## INDEX TO MINUTES

# MINUTES OF THE MEETING OF THE COMMISSION OF FINE ARTS HELD IN NEW YORK CITY, MAY 23, 1935

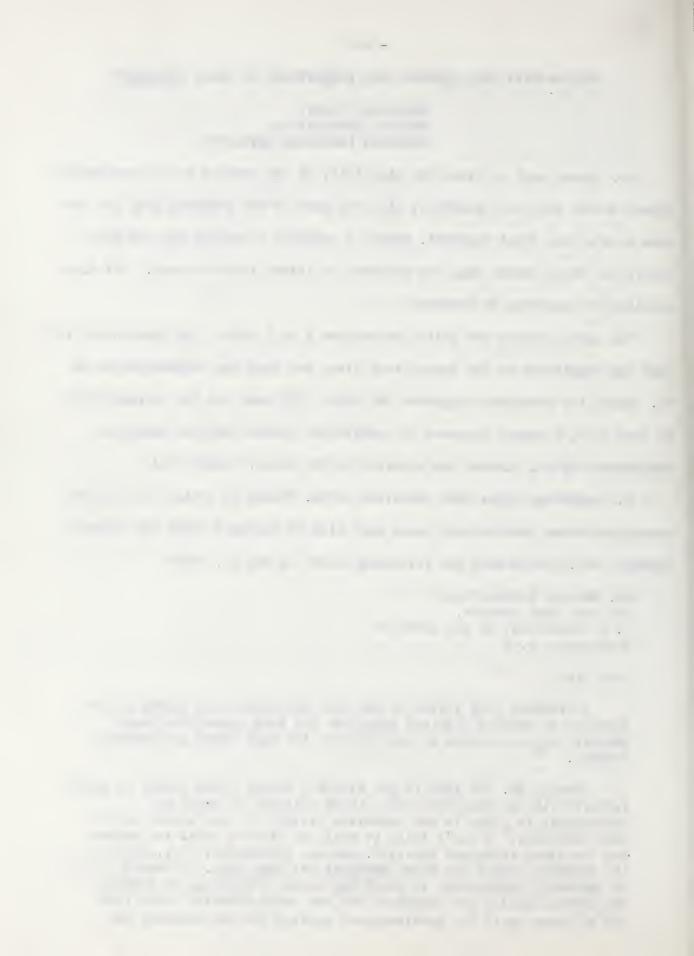
Mr. Clarke said he liked the simplicity of the granite paving proposed to extend around the Grant Memorial; also the part of the planting plan for the area east of the Grant Monument, which is intended to screen out the motor traffic on First Street when the monument is viewed from the west. The plan provides for planting of boxwood.

The paving stones are quite large--some 3 by 6 feet. The Commission felt that the simplicity of the paving very nice, and upon the recommendation of Mr. Clarke the Commission approved the plan. (To save the PWA appropriation by June 10th, a paving composed of granite and brushed surface concrete recommended by Mr. Olmsted was approved by Mr. Moore. (Exhibit A)

"I recommend that if practicable to do so without serious delay to the work, two changes be made in the construction details for Union Square prepared during my absence on account of illness.

"One should effect a saving in cost of \$15,000 or more without essential sacrifice in the general appearance of the
design as a whole. This would be done by using, inside the
granite borders of the paved platform around the Grant Monument, panels of brushed surface concrete, using an aggregate
of suitable color and texture. Quite apart from the saving
in cost there is a purely esthetic argument for introducing
panels of brushed surface concrete because of the fact that
all the rest of the path system of Union Square is designed
to be of such material, as are the paths of the Mall west of
Third Street, and all the new paths of the Capitol Grounds.

"The artistic gain from the introduction of panels of such material within the granite border of the platform for the Grant Memorial, through its tendency to unify that platform with its surroundings, would be an offset to any local diminution in the monumental qualities associated with a pavement entirely of granite. I have submitted this recommendation to Mr. Moore of the Commission of Fine Arts and find that he strongly concurs in it in principle. Mr. Howard is now making a drawing embodying what I propose.

"The second suggested change, which I think of great importance artistically, especially if the first change is made, relates to the aggregate to be used in the surfacing of any concrete pavements in Union Square. I had expected that they would be the same as in the Mall paths west of Third Street, but the

sample which has been selected for the latter and is now under contract, while excellent in itself and reasonable for its situation, is quite blackish in tone and would make far too strong a contract in close juxtaposition with the existing and proposed stone work in Union Square, especially with the large expanse of white marble in the Grant Monument.

"I strongly recommend that the brushed concrete pavement in Union Square be made closely similar in color and texture to that of the warm gray granitic concrete paving parallel to and immediately north of Constitution Avenue on the north axis of the Capitol."
